Amendments to approved drawings ref: 2020/4606/P

PROJECT
OAKLEY SQUARE, NW1

DRAWING TITLE
Amended Proposed Roof Extension 5th Floor

DRAWING NO	DATE	REV
2115-PL-113	15.07.2018	B

1 / 113 PROPOSED ROOF EXTENSION (5TH FLOOR)
1:150 @A3

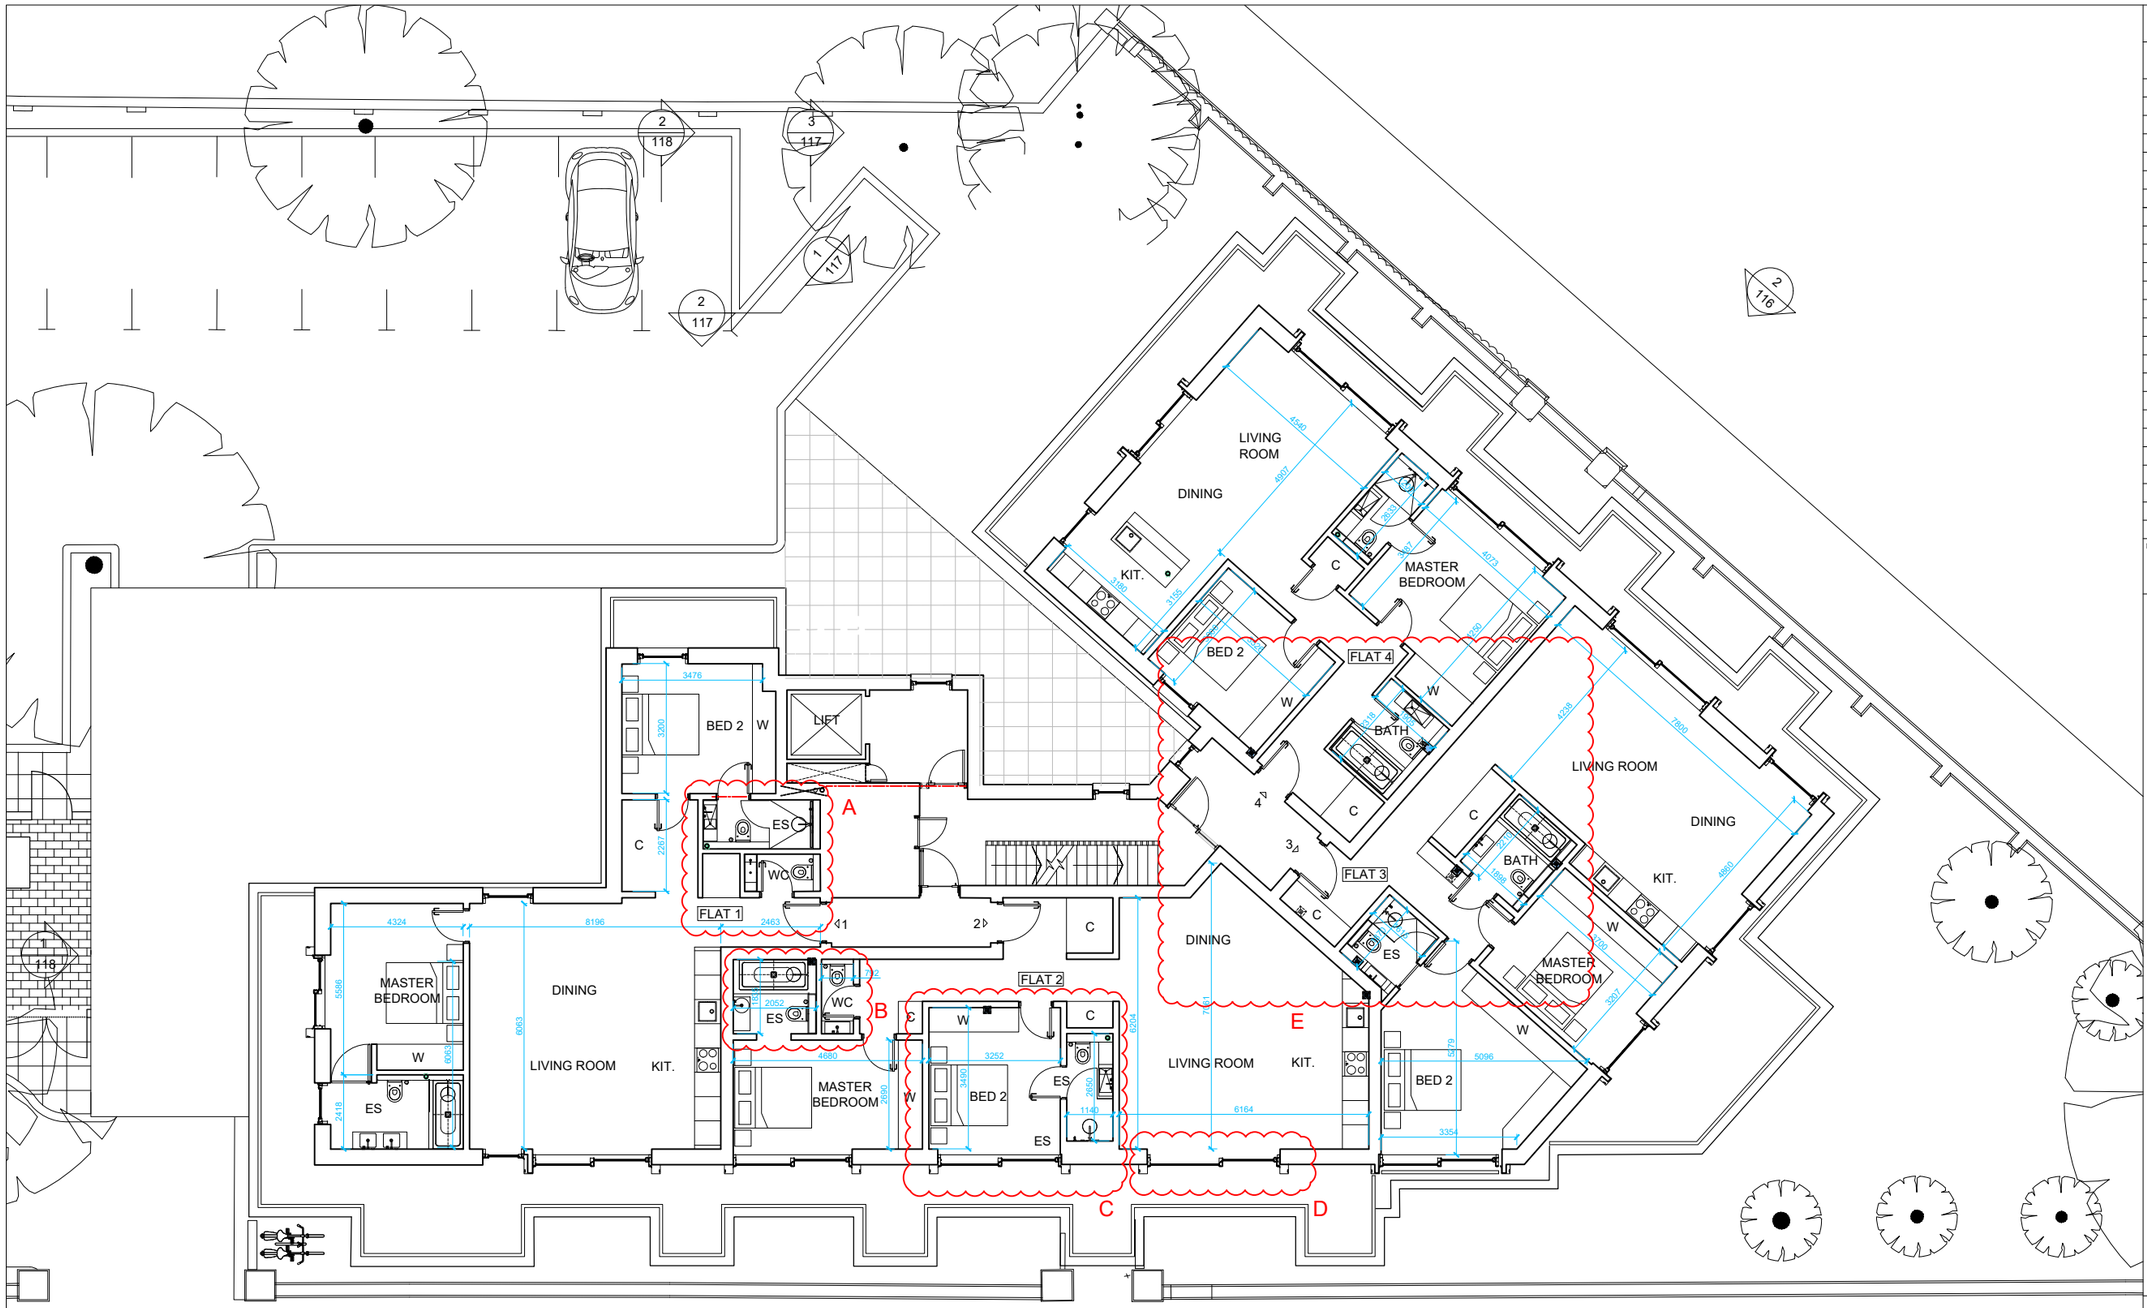
A - Bathroom to apartment 1 reconfigured

B - En-suite reconfigured to accommodate a cloakroom

C - En-suite repositioned to opposite side to improve bedroom layout

D - Bay window width reduced to a similar size to other openings balancing elevation

E- Communal hall and apartment entrances to units 3 & 4 reconfigured to match floor 6 for fire and acoustic separation. Bathrooms and Ensuites reconfigured to suite new apartment entrances.
